**THE TOWN OF TICONDEROGA**

**VETERAN'S ROAD CULVERT REPLACEMENT  
OVER FIVE MILE CREEK  
PIN 1761.09, D036296**

**AMENDMENT NO. 1**

**May 3, 2022 LETTING DATE**  
(Issued April 15, 2022)

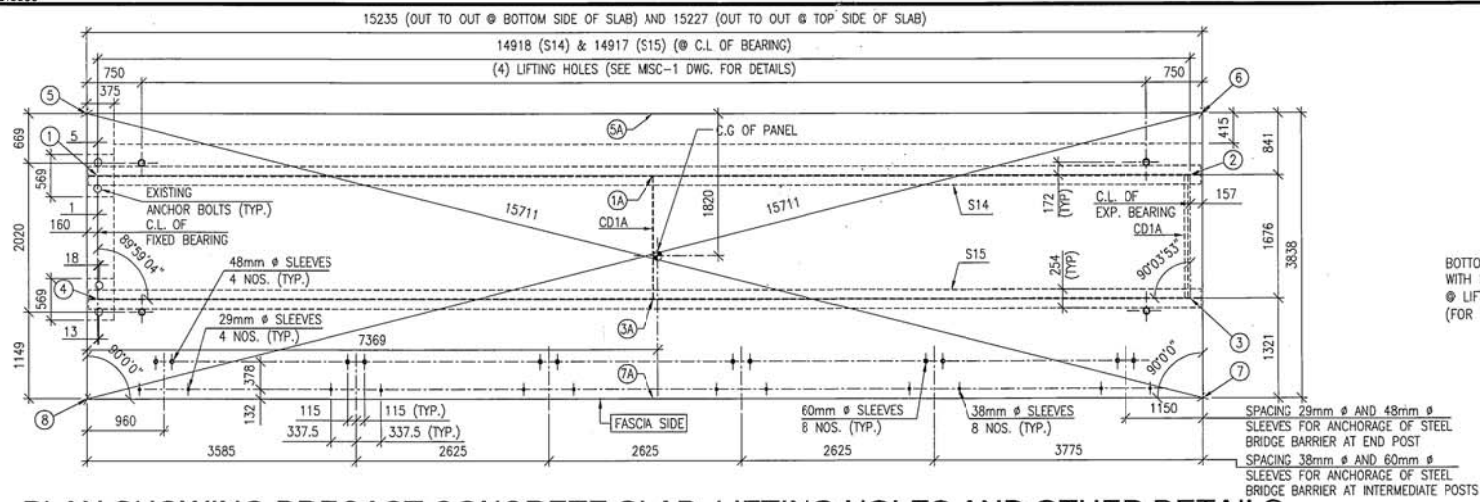
Old Sheet	New Sheet	Drawing #	Description of Changes
5	5A	GNN-1	Delete cofferdam notes.

- ~~SHOULD THE CONTRACTOR ELECT TO LAY BACK A PORTION OF THE EXISTING EARTH ADJACENT TO AN EXCAVATION REQUIRING A COFFERDAM, ANY REQUIRED EXTENSIONS OF THE COFFERDAM NECESSARY TO KEEP WATER FROM ENTERING THE EXCAVATION SHALL BE FURNISHED AND PLACED AT NO COST TO THE TOWN AND COUNTY.~~

- ~~WHERE A COFFERDAM IS USED, THE COST OF DEWATERING THE ENTIRE EXCAVATION, REGARDLESS OF THE SOURCE OF WATER, SHALL BE INCLUDED IN THE UNIT PRICE BID FOR THE COFFERDAM ITEM.~~

- ~~THE COFFERDAM(S) ARE TO BE CONTRACTOR DESIGNED. A COFFERDAM PLAN SHALL BE SUBMITTED TO THE ENGINEER FIFTEEN (15) DAYS PRIOR TO INSTALLATION.~~
- ~~DEWATERING OF THE COFFERDAM SHALL BE ACCOMPLISHED BY PUMPING THE WATER TO AN APPROVED UPLAND VEGETATED AREA OUTSIDE OF THE STREAMBED AS SHOWN ON THE PLANS AND/OR APPROVED BY THE E.I.C. TEMPORARY SOIL EROSION AND WATER POLLUTION CONTROL, SUCH AS STRAW BALES OR APPROVED EQUAL, MAY BE REQUIRED AS DETERMINED BY THE E.I.C. NO SETTLEMENT BASIN SHALL BE CONSTRUCTED.~~

THIS SHEET SUPERSEDES SHEET 5

Scale: AS SHOWN Drawn by: ASIM Job No: 06-005 Dwg. No: S145PD Sheet No: 1914

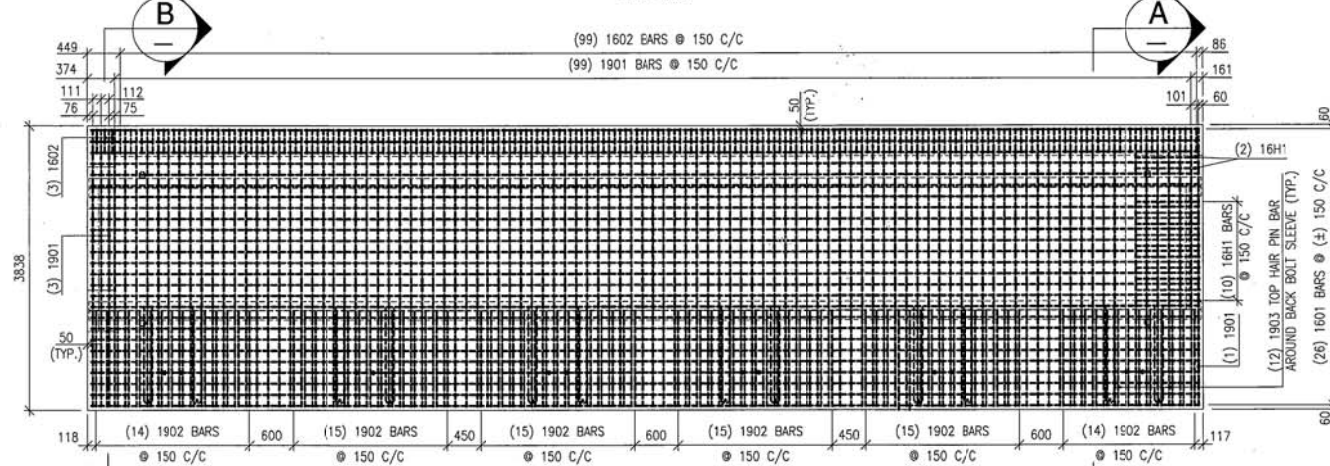
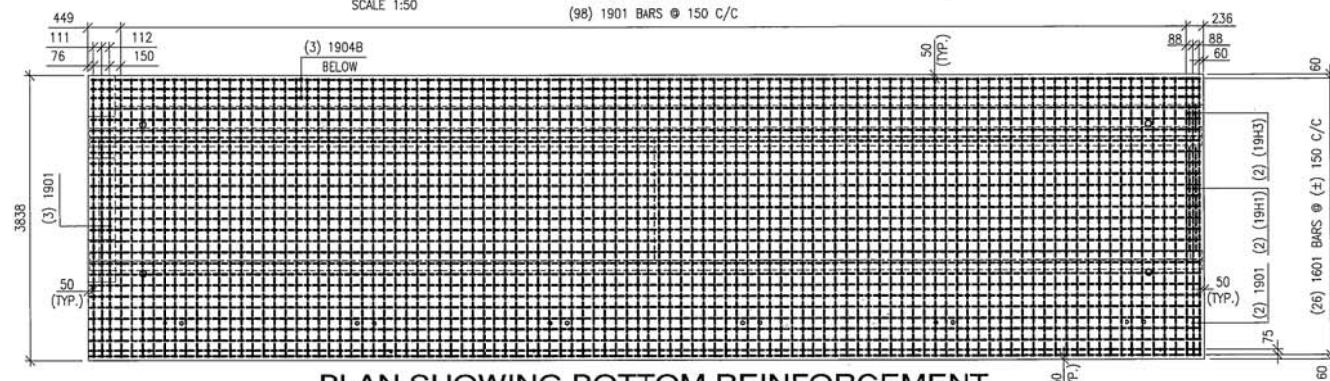
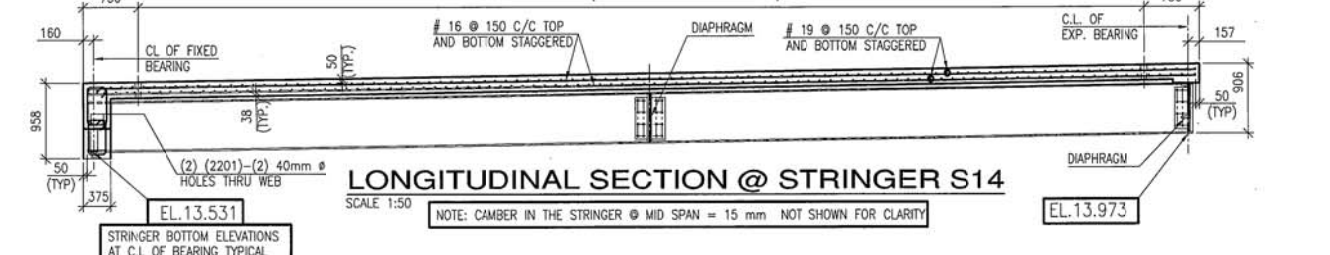
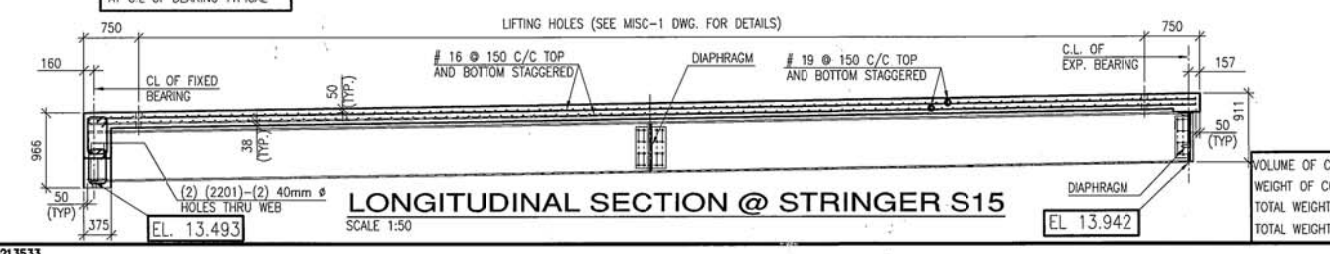
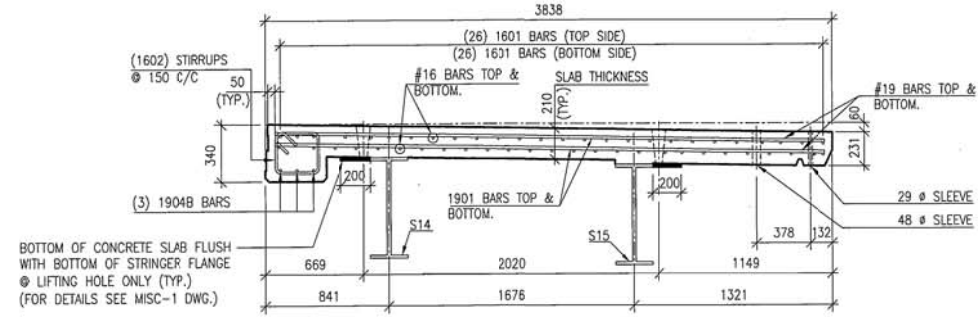
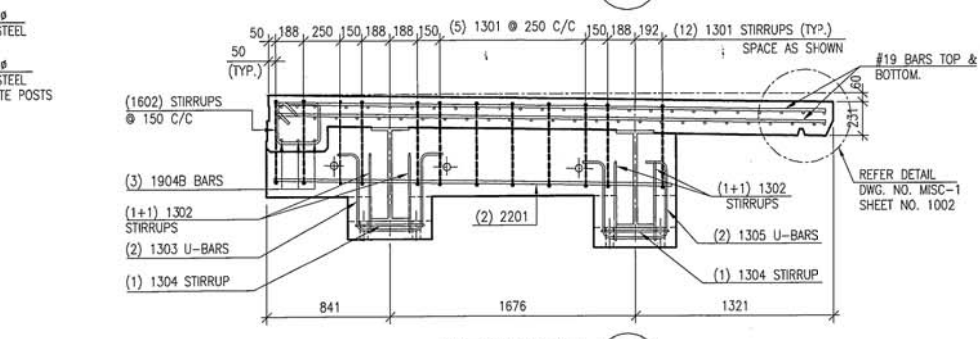
Contractor Question: Note 2 of the superstructure notes states that the record plans for the Tappan Zee panels are available. Can I get a copy of the panels getting placed? I completed a bridge similar to this and the weights were not as indicated. I found the panels to be much heavier than what was stated.

**The Tappan Zee panel record plans are attached to this amendment. The panels are the fascia panels and the total weight of each panel, as specified on the record plans, is 108 kips. The actual weight may be heavier than the stated weight.**
